PLANNING AND DEVELOPMENT DEPARTMENT

Staff Report Z-29-20-6

<u>Camelback East Village Planning</u> <u>Committee</u> Meeting Date	December 1, 2020
Planning Commission Hearing Date	January 7, 2021
Request From:	R1-10 (Single-Family Residence District) (0.48 acres)
Request To:	R-O (Residential Office – Restricted Commercial District) (0.48 acres)
Proposed Use	Wellness center
Location	Southeast corner of 44th Street and Calle Allegre
Owner/Representative/Applicant Staff Recommendation	Michael and Monica Samuels Approval, subject to stipulations

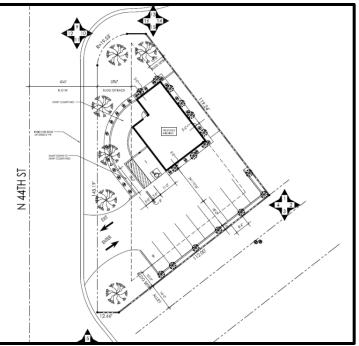
4. The proposed site plan depicts an approximately 2.063-square-foot wellness center building positioned to the northeast of the lot. Of this area, 880 square feet will be at ground level, while the remaining 1,183 square feet will be underground. Due to the irregular configuration of the lot, the northeastern property line is considered the rear yard. As such, the proposed development will require a variance to reduce the setback requirement to accommodate this site layout. Staff is not recommending general

conformance to the site plan for this reason. Adjacent to the site along this northeastern property line is a single-family home. To ensure appropriate buffering, staff is recommending that a minimum 10-foot-wide landscape setback be provided along this property line, which should be planted with minimum 2-inch caliper trees 20 feet on center or in equivalent groupings. This is addressed in Stipulation No. 3.

- b. Drought tolerant shrubs and vegetative groundcovers to provide a minimum of 75 percent live coverage at maturity.
- 3. A minimum 10-foot landscape setback shall be provided along the northeastern property line, where the property abuts a single-family home. This landscape setback shall be planted with minimum 2-inch caliper trees planted 20 feet on center or in equivalent groupings, as approved by the Planning and Development Department.

southeast elevation

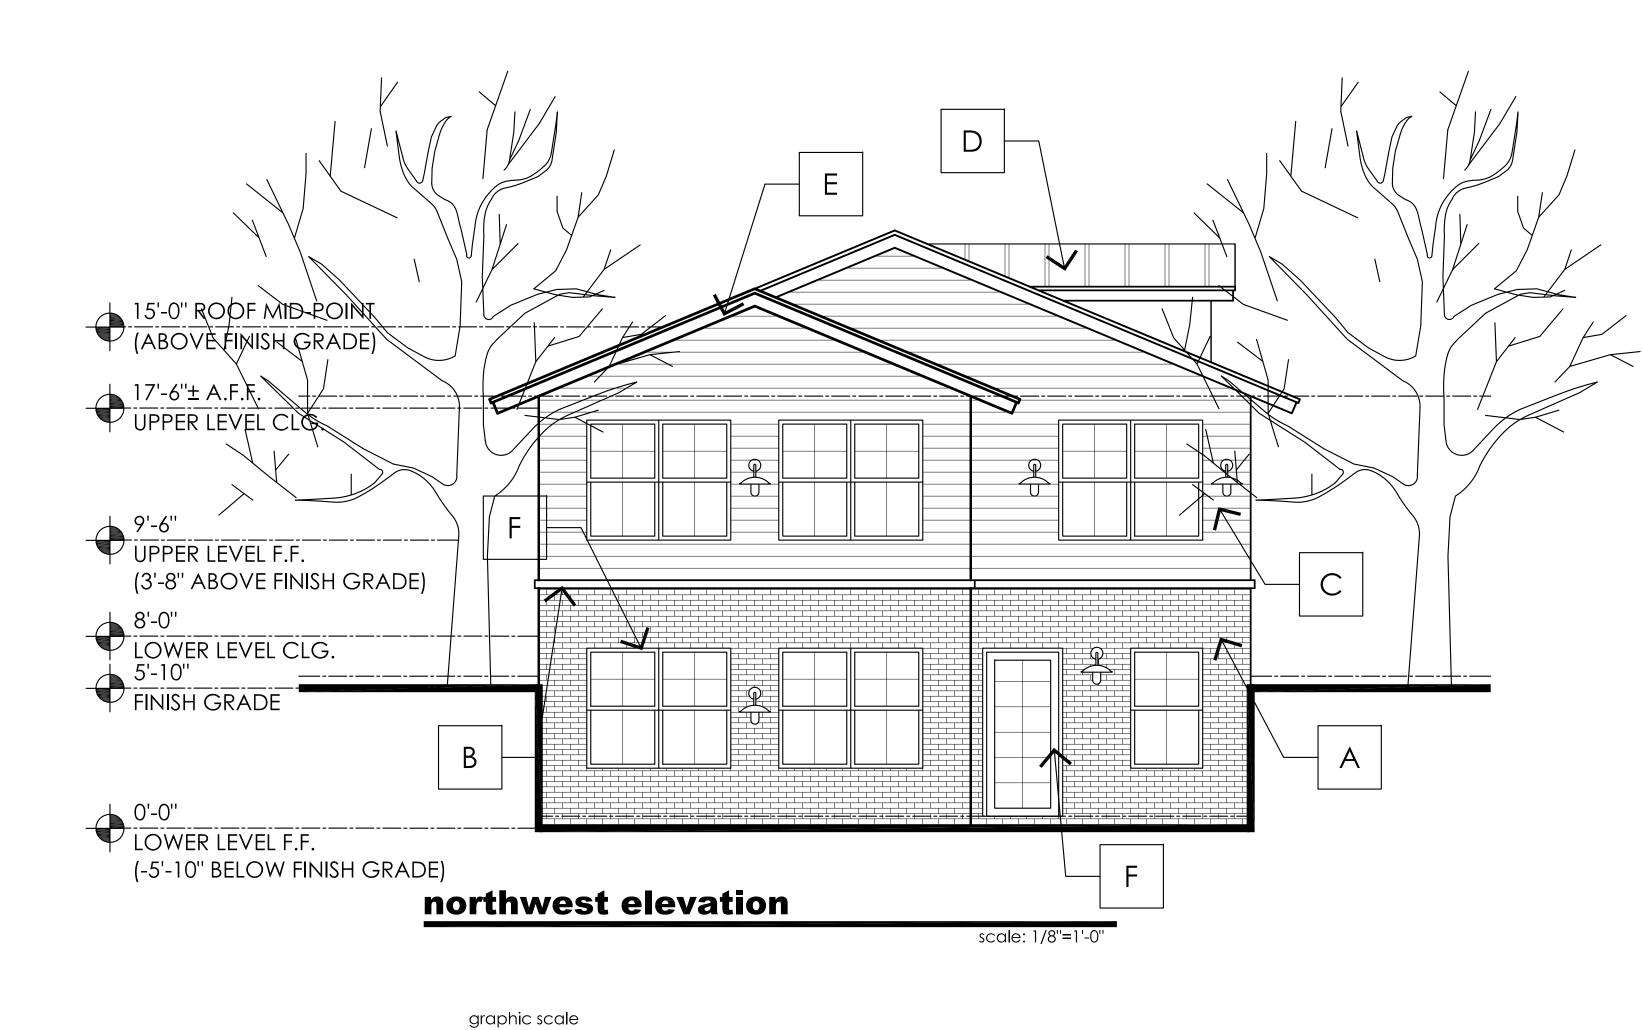
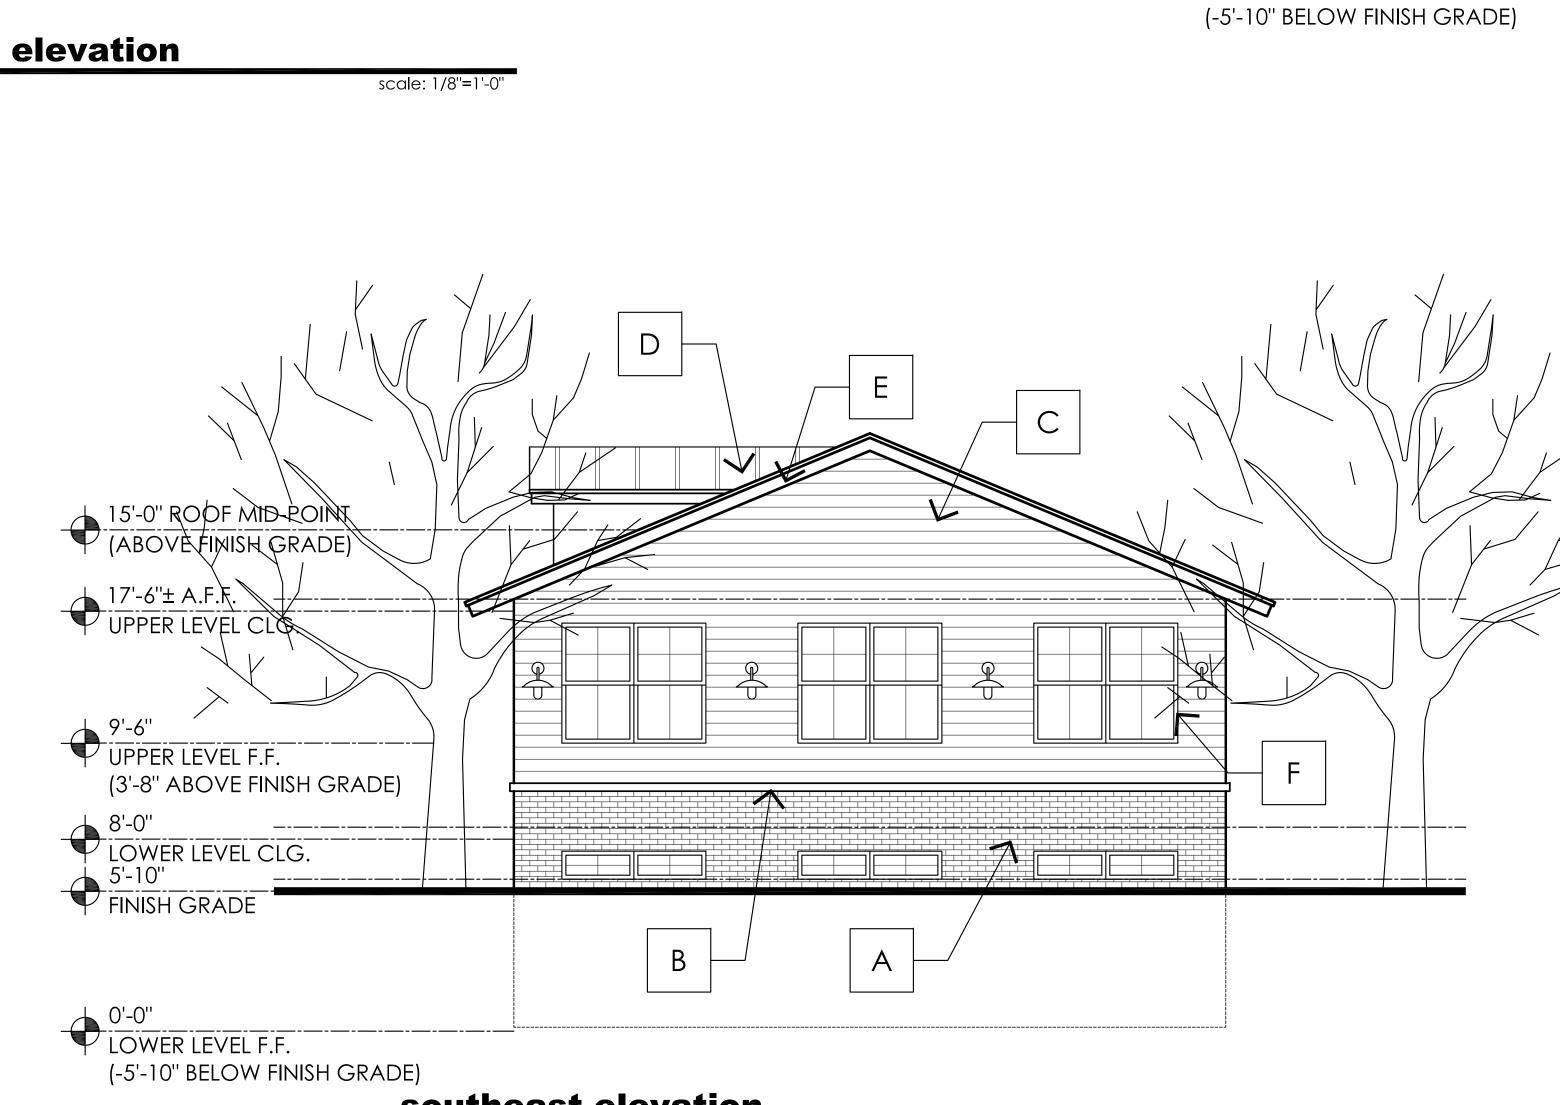
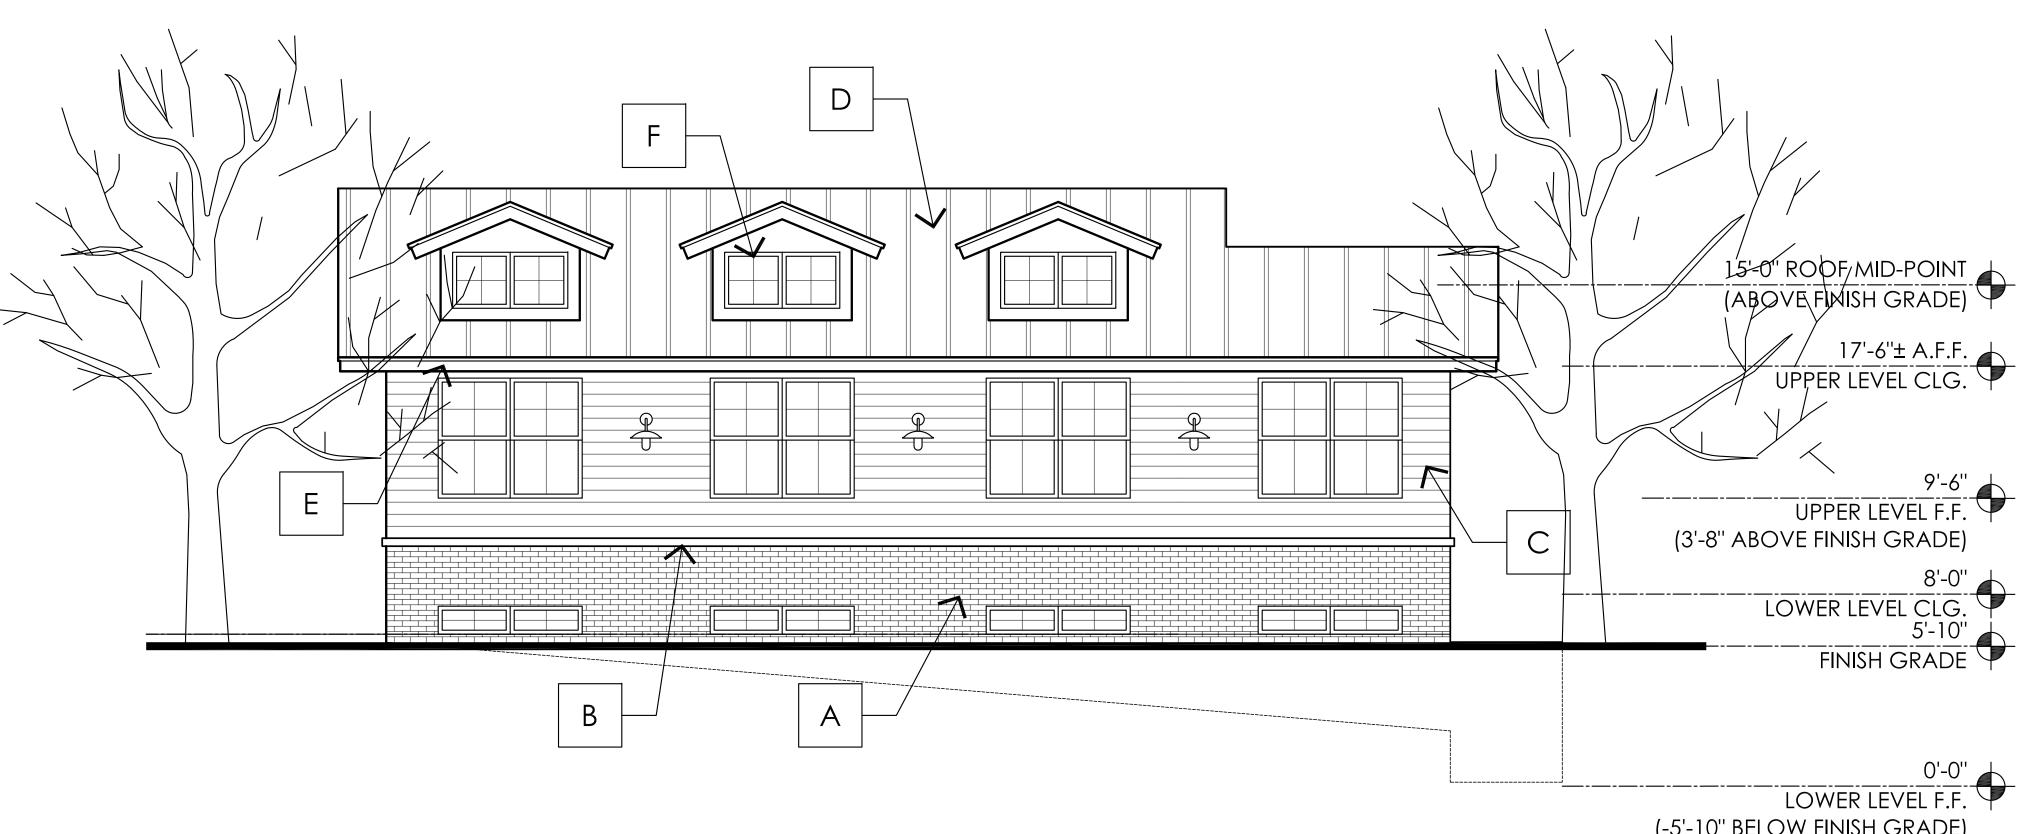
5. The proposed building will have a maximum height of two stories and 15 feet, with a basement level that will be partially underground. This will allow the building to remain consistent with the height and design of the surrounding homes and will minimize disruption to the streetscape. Further, the proposed building elevations emulate a residential architectural style, with brick veneer, horizontal siding, pitched roof, and large windows throughout. Staff is recommending general conformance to the elevations date stamped June 11, 2020, with specific regard to these architectural elements. This is addressed in Stipulation No. 1.

14. At the time this staff report was written, staff received one letter of concern regarding the proposed two-story elevations.

Hi Sofia, I write regarding the proposed rezoning. I live at 4314 E Calle Redona, Phx. While I favor reuse and redevelopment generally, I am concerned about redevelopment elevations. I currently have a view to Camelback mountain that enhances my property value. While I do not believe this particular proposal blocks my view, it does set a precedent for 2 story redevelopment on 44th St if I read the site plan properly. If that is the case, I ask that the plan be modified to 1 story. My concern being that once 1 property is structured as 2 story, other developments will follow that may well block my view.

- 1. The development shall be in general conformance with the elevations date stamped June 11, 2020, with specific regard to use of brick veneer and horizontal siding, the locations and size of windows, and roof design, as approved by the Planning and Development Department.

Thank you for your feedback. Just to clarify, the proposed building will be built with two levels, with much of the lower level below grade, and not 2 stories above ground. It will meet all height restrictions. Additionally, with an alley southeast of the lot, 44th street in front to the west, and Calle Allegre (and Camelback Mountain) to the northeast, the building will not obstruct anyone's view of Camelback. Have a great day! Mike
